HOPE CREEK GENERATING STATION  
DOCKET NO. 50-354  
FSAR COMMITMENT STATUS THROUGH AUGUST 1984

ATTACHMENT I  
HOPE CREEK GENERATING STATION  
FSAR COMMITMENT STATUS THROUGH AUGUST 1984

QUESTION 220.21 (SECTION 3.7.2)

FIGURE ~~210.21-43~~ 210.21-43  
 RESPONSE SPECTRA COMPARISON,  
 INTAKE STRUCTURE AT ELEV. 93' -0",  
 E-W, SSE, 2% DAMPING

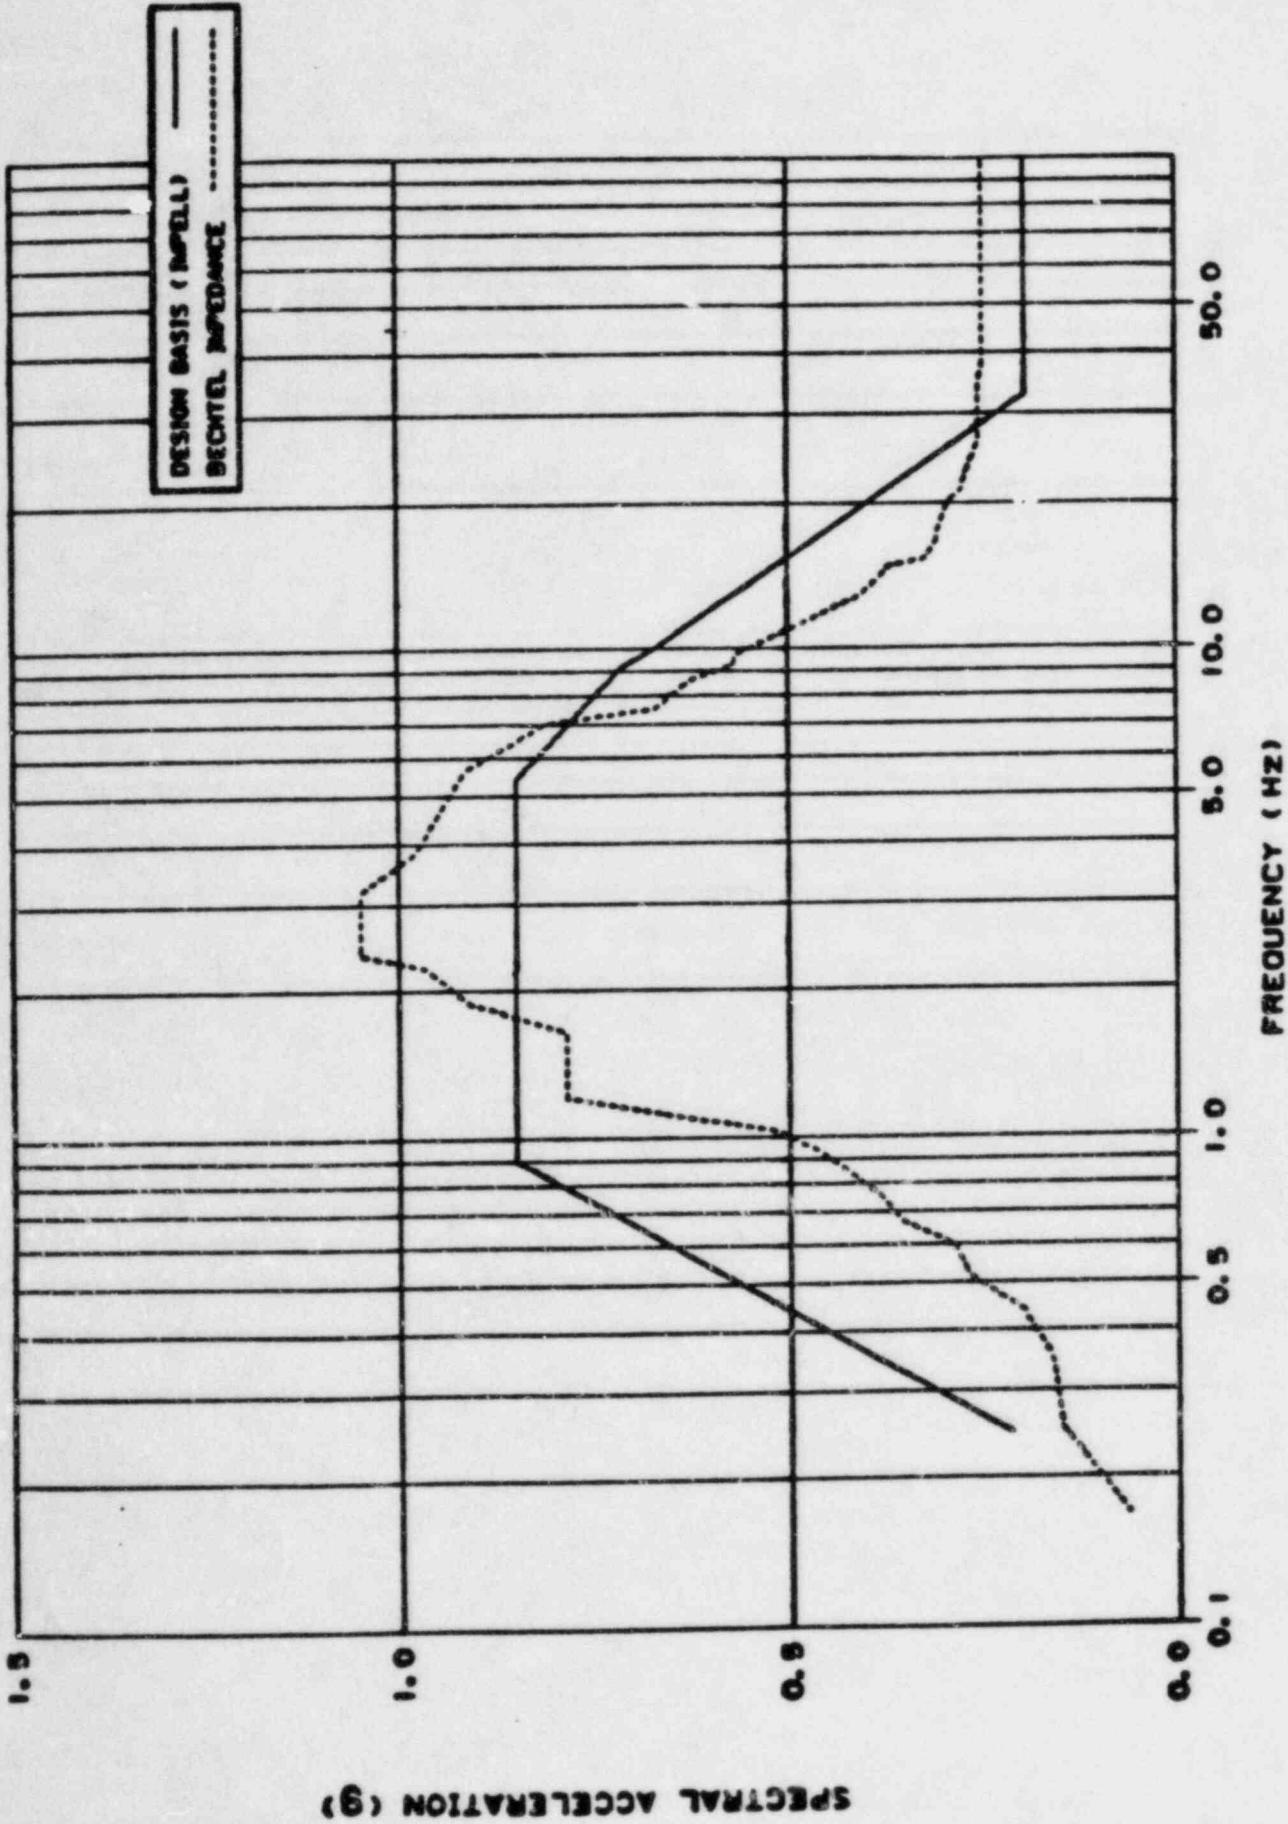
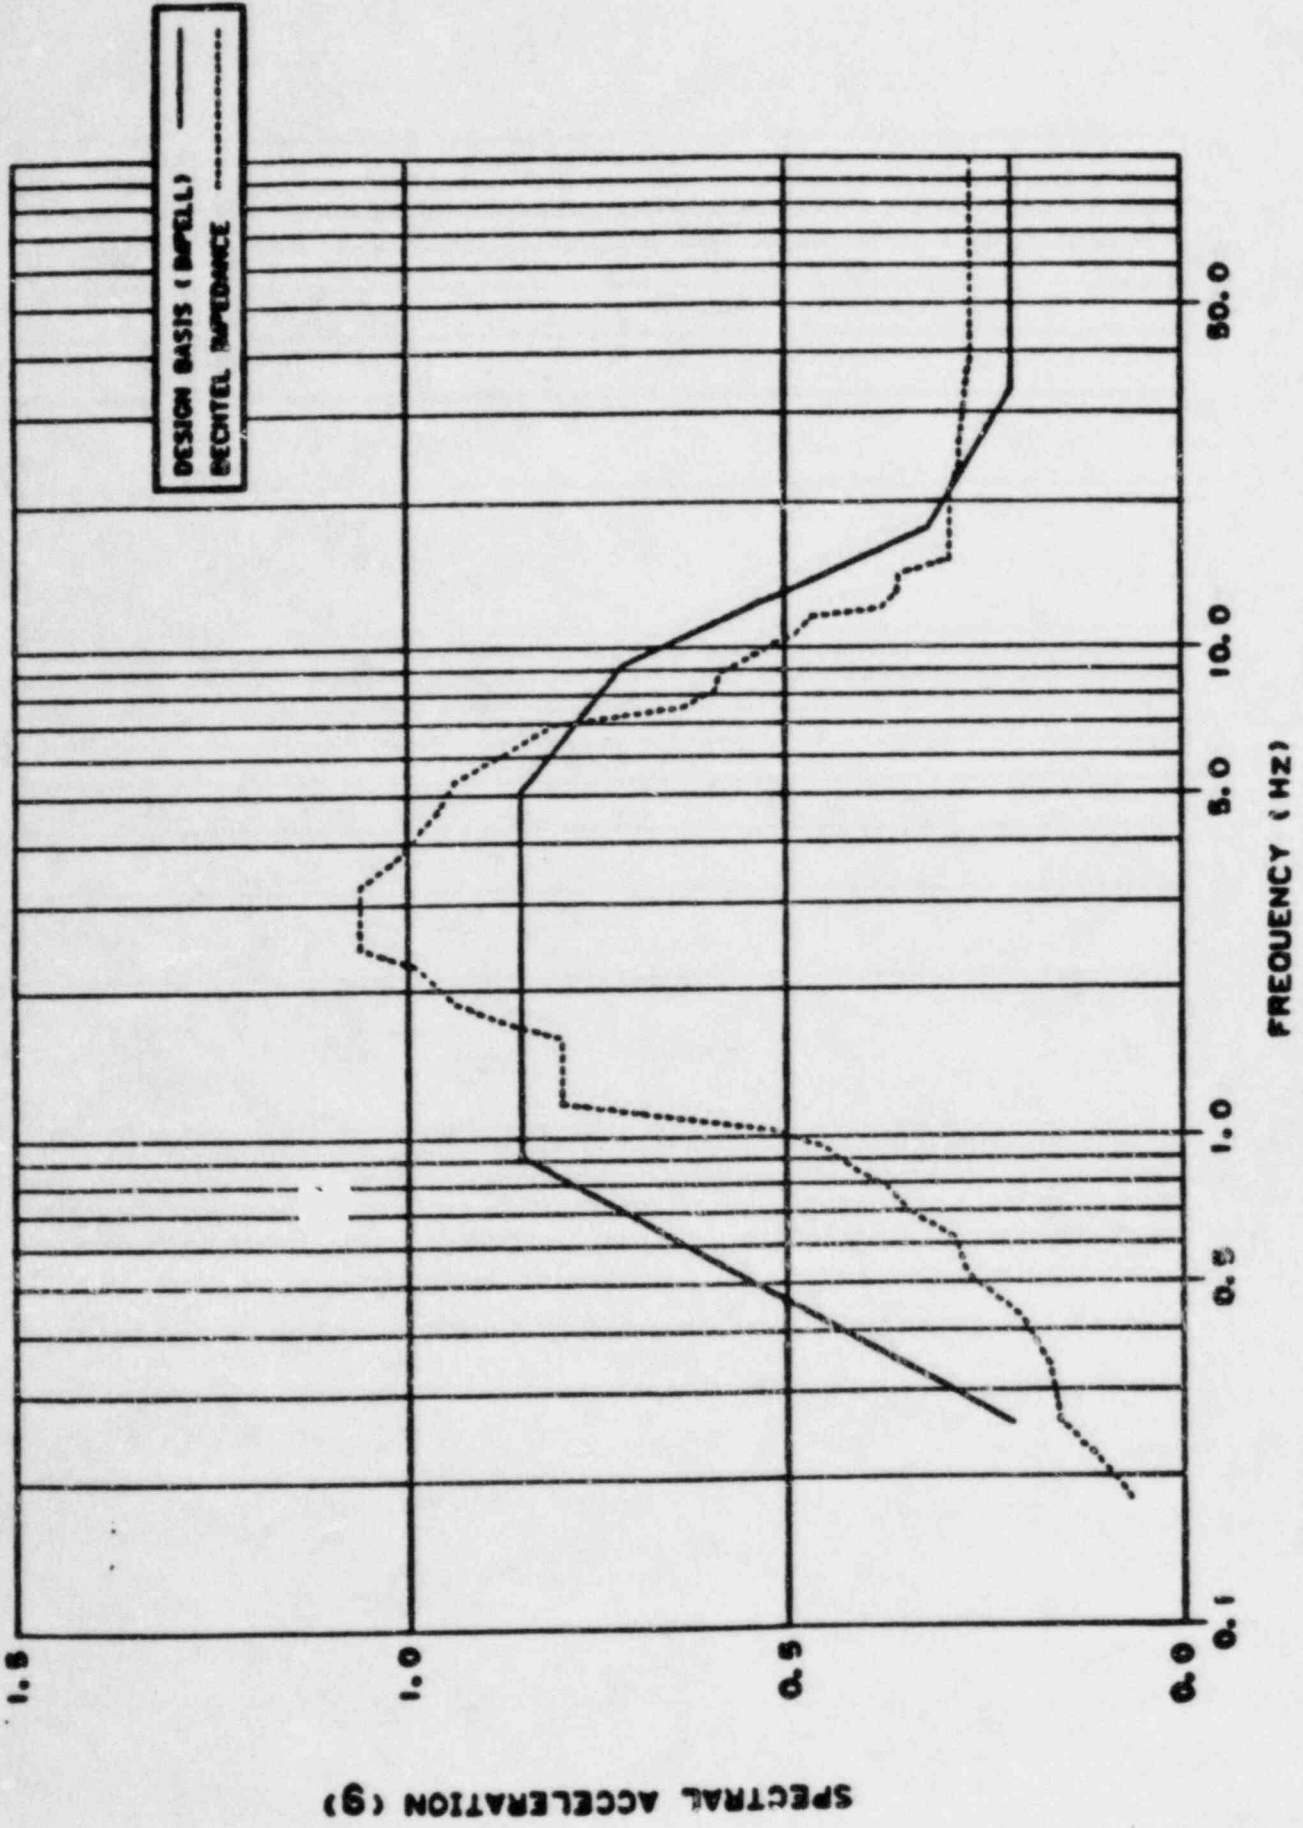
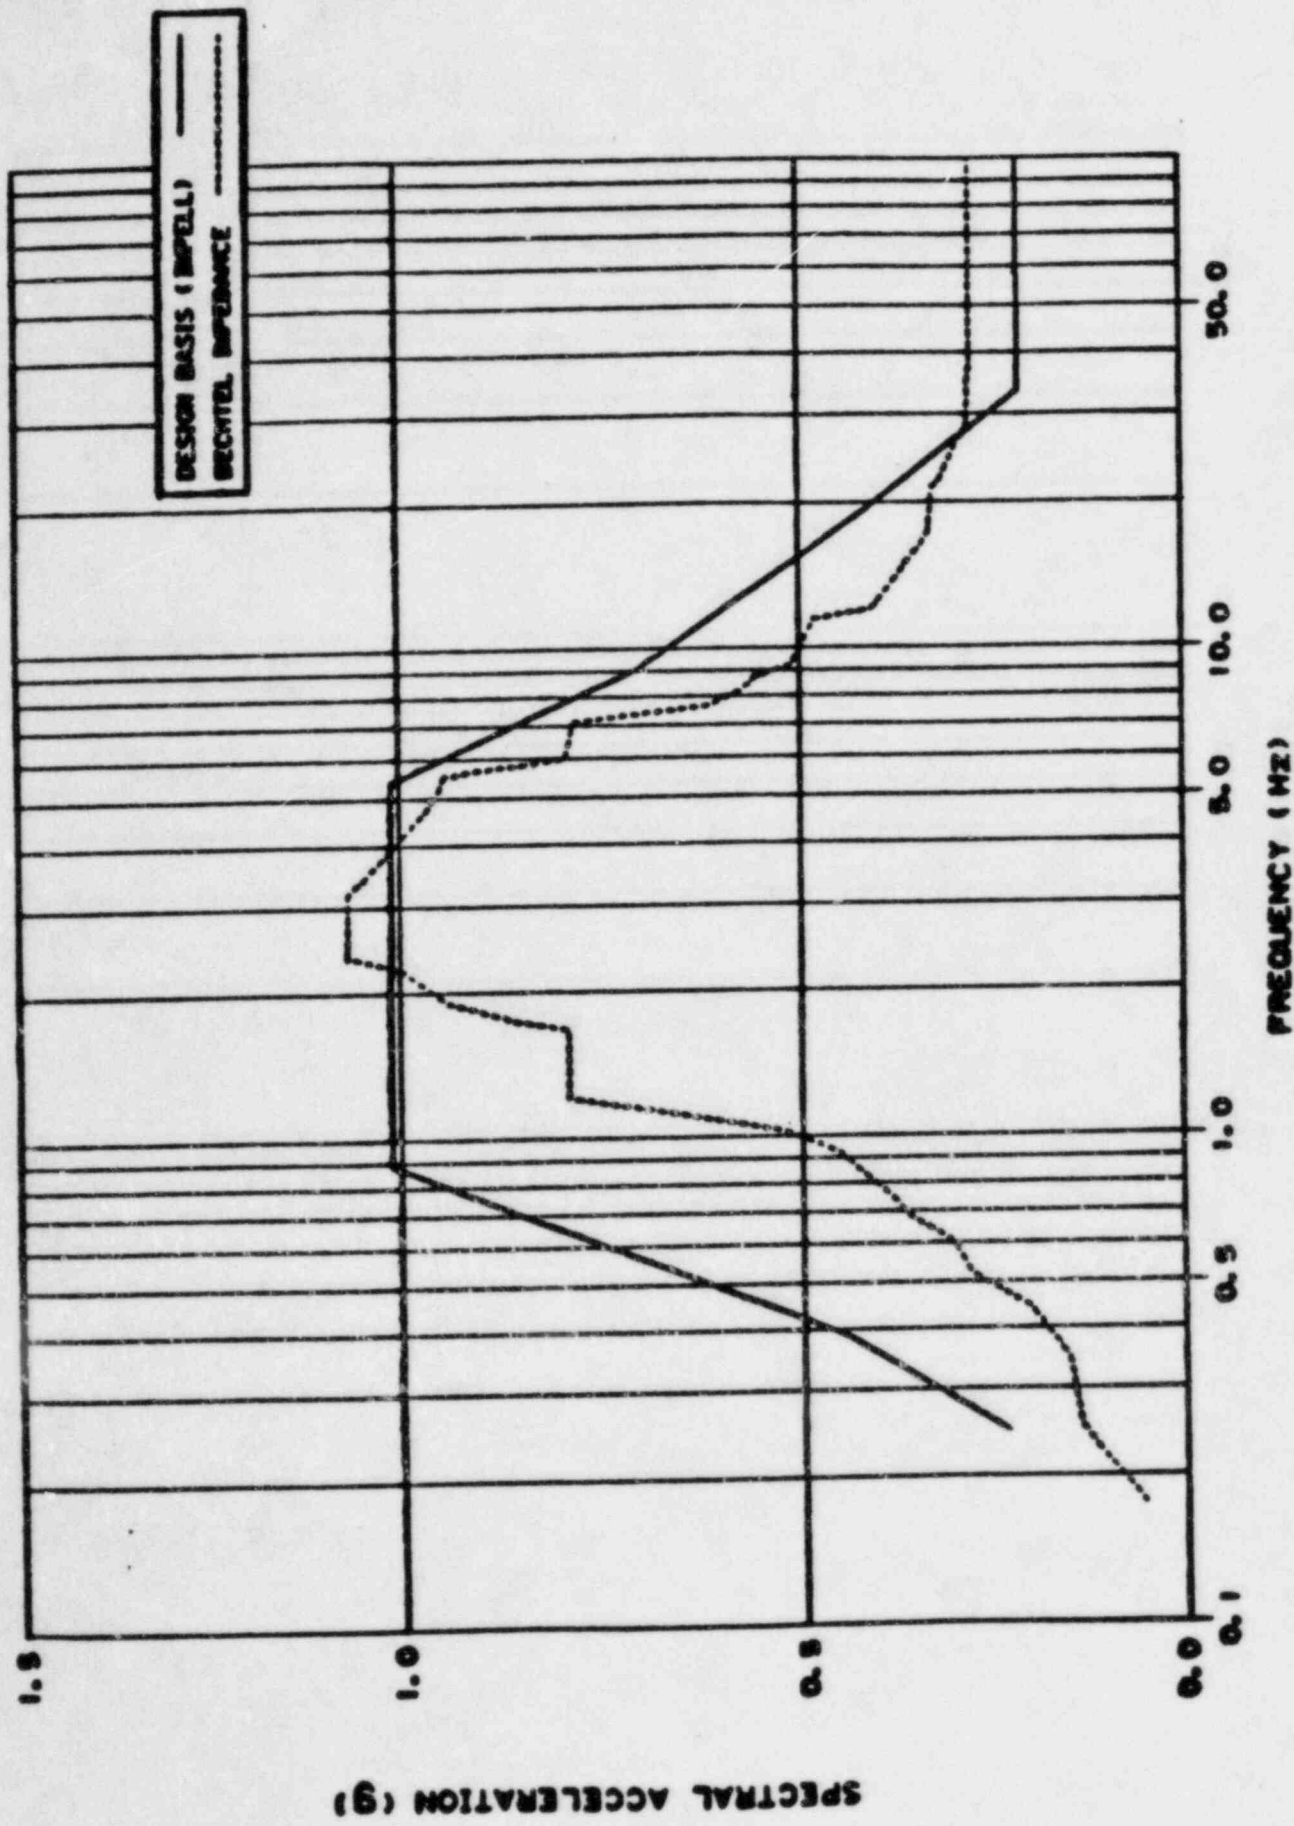
The Hope Creek soil-structure interaction analysis is performed by applying a specified earthquake input motion at the base of the finite-element model. The base level input motion is generated through a deconvolution analysis. The applicable SRP criteria for soil-structure interaction analysis require that both the half-space and finite-element approaches should be considered. (For details refer to SRP 3.7.2-11.4). Public Service should perform necessary analyses to demonstrate conformance to the criteria.

Figures 220.21-1 through 220.21-54 show a comparison of the 2 percent damping response spectra obtained from the design basis finite element and the impedance analyses for the reactor building, auxiliary building and the service water intake structure (SWIS).

¶ For the reactor and auxiliary buildings, the peak spectral accelerations obtained from the impedance analysis are generally lower than those obtained from the design basis analysis. However, the impedance analysis response spectra are not completely enveloped by those obtained from the design basis analysis, especially in the frequency range from 1.0 to 3.5 Hz. Also, there are some local exceedances in the higher frequency range, as shown in Figures 220.21-1 through 220.21-36. ¶ For the SWIS (Figures 220.21-37 through 220.21-54), the impedance analysis response spectra are generally enveloped by those obtained from the design basis analysis at elevation 114.0 feet. For other elevations, the impedance analysis spectral accelerations exceed the design basis spectral accelerations in some frequency ranges. These ranges vary approximately between 1.5 and 10.0 Hz.

forces and moments obtained from the impedance analysis exceeded the design basis values at various locations within these buildings. The auxiliary building seismic shear forces and moments obtained from the impedance analysis are less than the design basis shears and moments.

Since the impedance analysis results are not completely enveloped by the design basis finite element analysis results, sampling studies are conducted to confirm the adequacy of the plant design. These sampling studies include an evaluation of the following items:

In all cases, the items reviewed during these sampling studies can accommodate the loads resulting from the impedance analysis. Therefore, the impedance analysis results have no impact on the plant design.
